# Groundwater Application Review Summary Form

Application # G- 18751

# MEMO

**To:** Kristopher Byrd, Well Construction and Compliance Section Manager  
**From:** Joel Jeffery, Well Construction Program Coordinator  
**Subject:** Review of Water Right Application G-18751  
**Date:** February 7, 2019

### Water-Level Trends in Nearby Wells

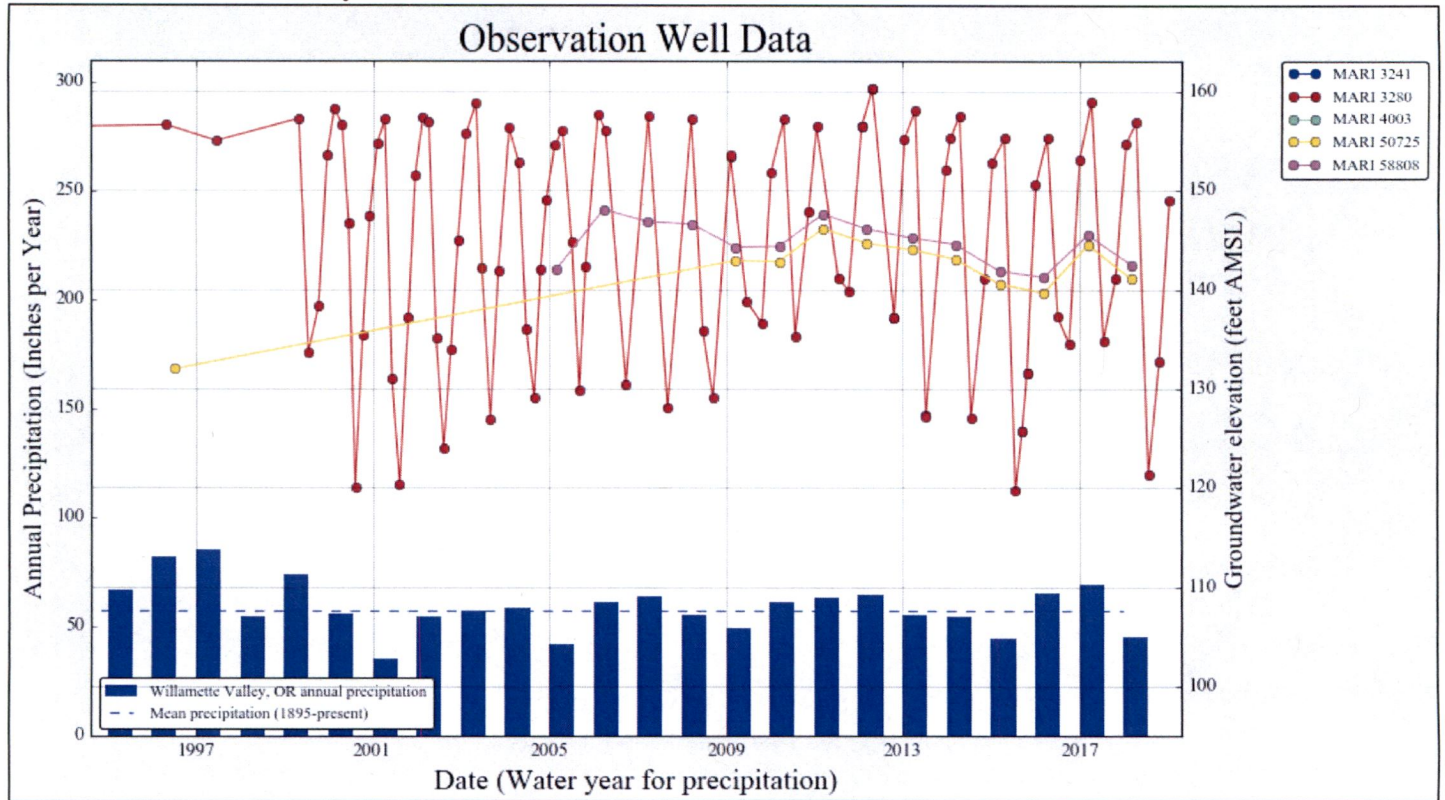
About 100 feet of saturated sands and gravels are confined beneath about 80 feet of Willamette Silt in the vicinity of the subject wells. Seasonal water-level fluctuations in the sand and gravel aquifer are estimated to be 30-40 feet/year based on the hydrograph for MARI 3280, a nearby observation well (located approximately 2.3 miles to the east-southeast across the Pudding River). Both the proposed well (MARI 58808) and well 3 (MAI 50725) from the cancelled permit (G-15851) were measured as a permit condition. The hydrograph (see below) shows fairly stable spring water levels at MARI 3280 and water levels at the applicant's location showing a somewhat cyclic pattern possibly driven by climatic factors.

Stream Depletion Model Results

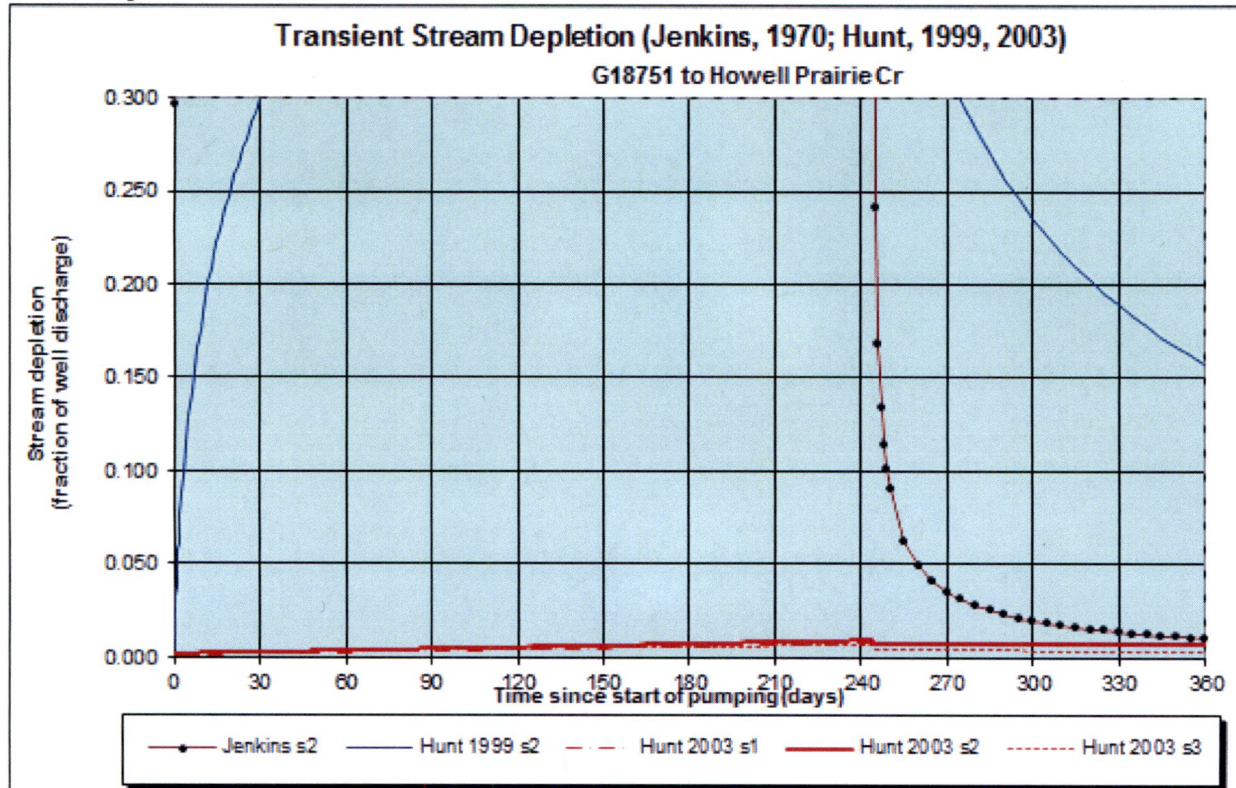
**Comments:** Potential depletion of Howell Prairie Creek by production at the proposed POA (MARI 58808) was estimated using the Hunt 2003 stream depletion analytical model. Analytical modeling results for the proposed POA shows that estimated interference at 30 days is less than 25% of well production. The thickness of the silt and associated fine-grained sediments in the area between the well and the stream (about 50 feet) was estimated based on maps in Gannett and Caldwell (1998), nearby wells, and land surface elevations from topographic maps. Aquifer thickness averages about 100 feet in the vicinity of the proposed wells.
